The Northern Road Upgrade – Mersey Road, Bringelly to Glenmore Parkway, Glenmore Park

Submissions and Preferred Infrastructure Report Volume 1: Main Report

Roads and Maritime Services | December, 2017

Figure 2-2 Cross section of the proposed culvert at the unnamed tributary of Surveyors Creek

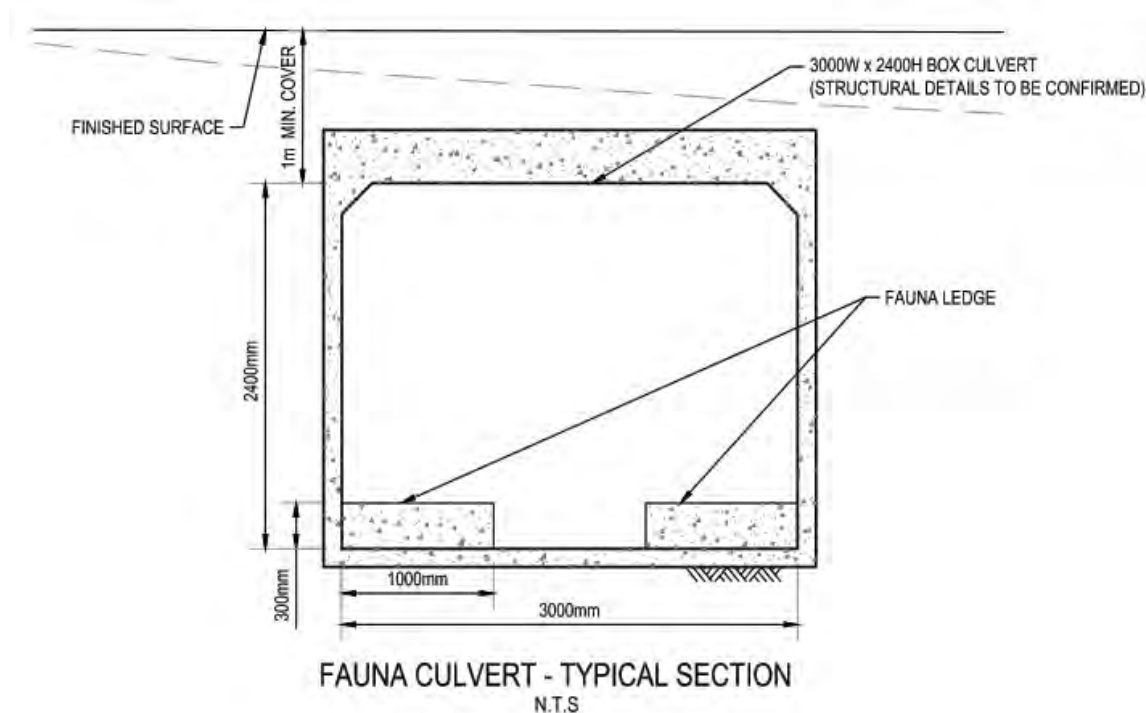
Connectivity between the Mulgoa Nature Reserve and the DEOH via Regional Corridor 17 (Surveyors Creek corridor) would be planned for in the future with construction of a fauna crossing to allow for future connectivity to the DEOH land. The proposed fauna crossing is currently a 2.4 m high dry passage underpass (refer to Figure 2-2). This is considered suitable for larger species such as the Eastern Grey Kangaroo based on monitoring results from Pacific Highway projects. However, the potential to increase the height of this underpass would be investigated during detailed design of project where reasonable and feasible. The culvert would lead from the Surveyors Creek corridor under the road and would exit at the new DEOH fencing within the road reserve. There is a second culvert that leads from this road reserve into the DEOH site. For DEOH security reasons, this second culvert would be blocked via bars at about 180mm spacing onto DEOH land. This is to prevent the public from gaining unauthorised access to the DEOH land through the underpass and to prevent animals from exiting the culvert onto the roadway. The bars would remain in place until a change in potential future land use would allow the removal of the DEOH fencing. While this would preclude larger animals crossing into the DEOH in the short term,

Figure 2-3 Cross section of the proposed culvert at Badgerys Creek

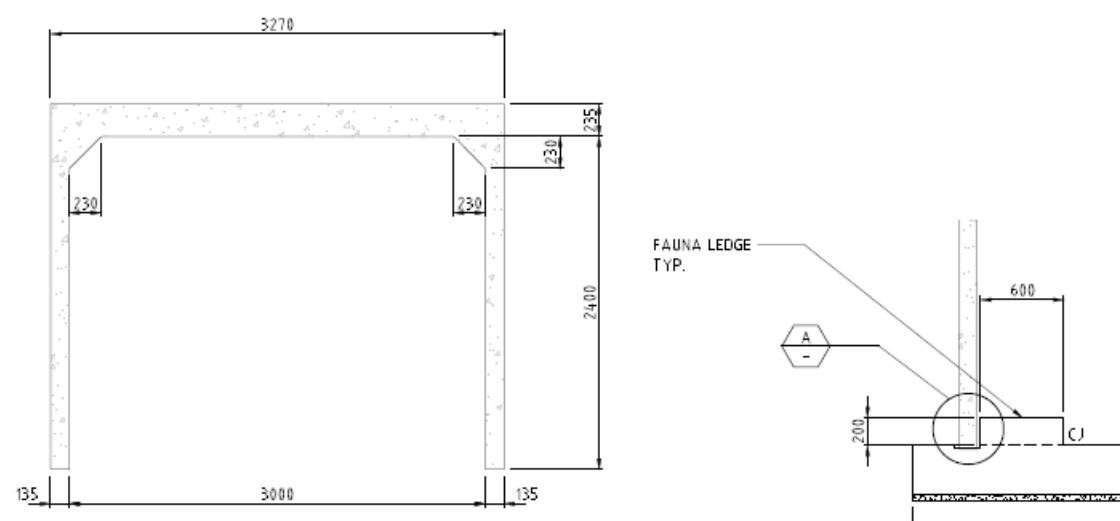
Fauna passage would also be provided at Badgerys Creek with the construction of a fauna friendly drainage culvert of similar internal dimensions to the Surveyors Creek / DEOH culvert (refer to Figure 2-3).
